GOVERNMENT OF THE DISTRICT OF COLUMBIA
DEPARTMENT OF TRANSPORTATION

MEMORANDUM

SUBJECT: **Zoning Commission Case No. 15-14** – District of Columbia Water and Sewer Authority

Figure 1. Site Plan (Source: Applicant)

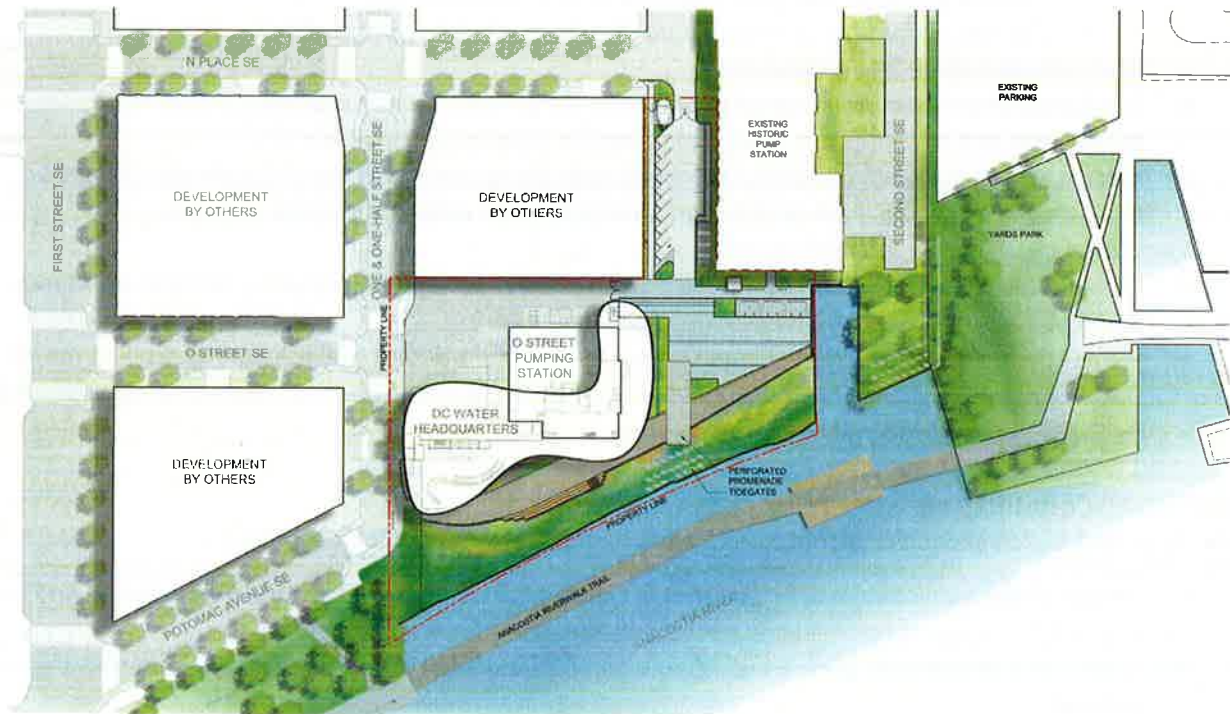
This Site is located between N Place SE and Canal Street SE to the north, the Anacostia River to the south, and private property to the east and west, with no alley network present. Loading vehicles access the Site from the west at a gate on what will be 1½ Street SE. Currently, this area is a DC Water facility, and thus in the interim condition any trucks will need permission to pass through this active yard. Personal vehicles access the Site from the north through a gate off N Place SE, which leads to the provided 20 vehicular parking spaces. The proposed vehicle site access is consistent with DDOT's approach to site access. It is unclear, however, specifically where vehicles parking offsite will access those facilities.

The public bicyclist and pedestrian access point is located at the same north entry point, where all visitors will pass through a secure gate and guard booth. Employees will also be able to access a gate on the east side of the parcel between the existing historic pump station and coal slip. In the future, employees will also be able to access a west entrance. The entire Site will be securely fenced, and once within the perimeter people will be able to move throughout most of the area, except the active loading area and existing small pump station.

The only public roadway abutting this Site is N Place SE. As such, public space improvements will be anticipated at this location to bring it to full DDOT standards, including provision of a sidewalk across the entrance driveway. Additional offsite improvements to provide pedestrian access to the transit network are anticipated as well, which are detailed within the pedestrian analysis section below. These elements will be finalized during the public space permitting process. Other further improvements will occur in private space, and are also outlined within the appropriate modal analysis following.

- Design of the public realm specifically at N Place, which is the only abutting public street, and for which full improvement will be expected adjacent to this property; and
- A loading management plan, which should be provided as part of the public space permitting process.
